ISR Required Snocross snow flap retention

BULLETIN NO. 20/21-002 DATE: 16 Sept 20

SUBJECT: All Classes are required this snow flap construction

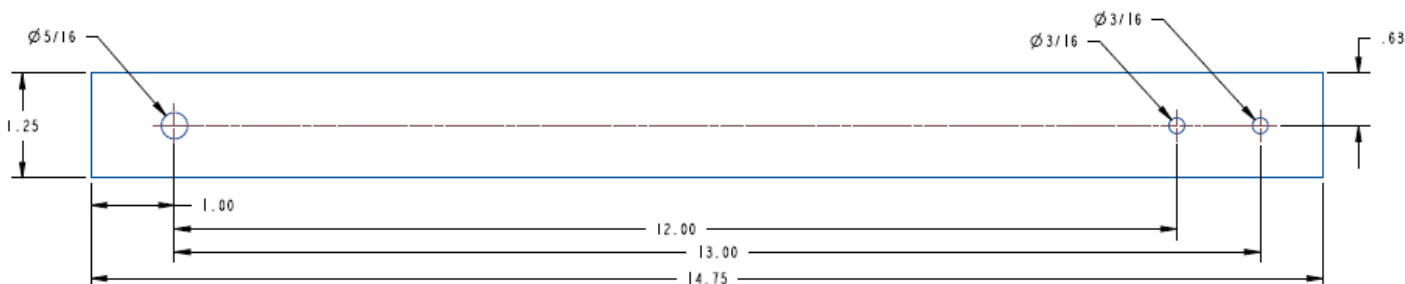
From each end of the rear bumper (see above picture for starting measuring point) measure up and make a mark at 21.125" and 22.125". Transfer the marks to the underside of the rear bumper. You will drill these holes in the rear bumper with a 3/16" Drill. The screws (7518280) will self-tap into the aluminum rear bumper.
